**Appeal Against Conditions attached to
Fire Safety Certificate (FSC/16/1632)**

Appeal Ref: 29B. FS0532

Project **Office Development at Harcourt
Terrace Lance, Harcourt Terrace,
Dublin 2**

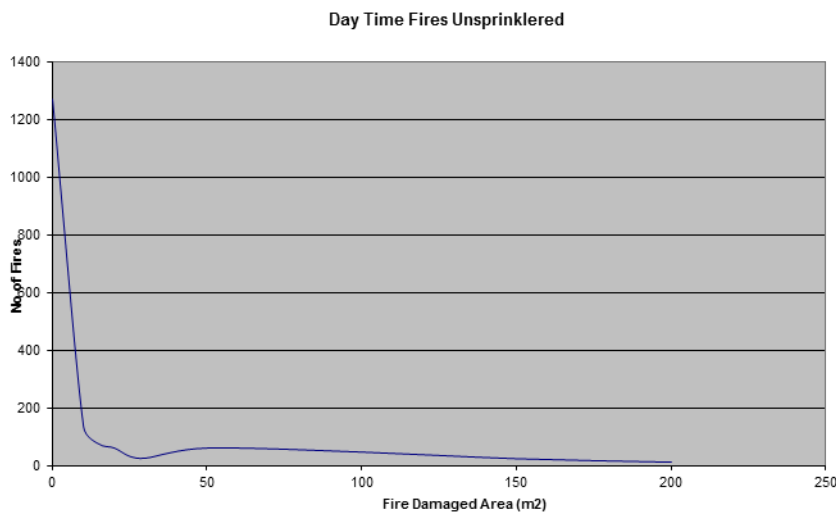
The road is more than the required 3.7m wide (4.3m kerb to kerb) and has a turning facility for a fire appliance at the end. Auto-tracking analysis has been done to demonstrate that a pumping appliance can drive into the site and reverse out of it. Three fire hydrants are provided, despite the building only requiring one.
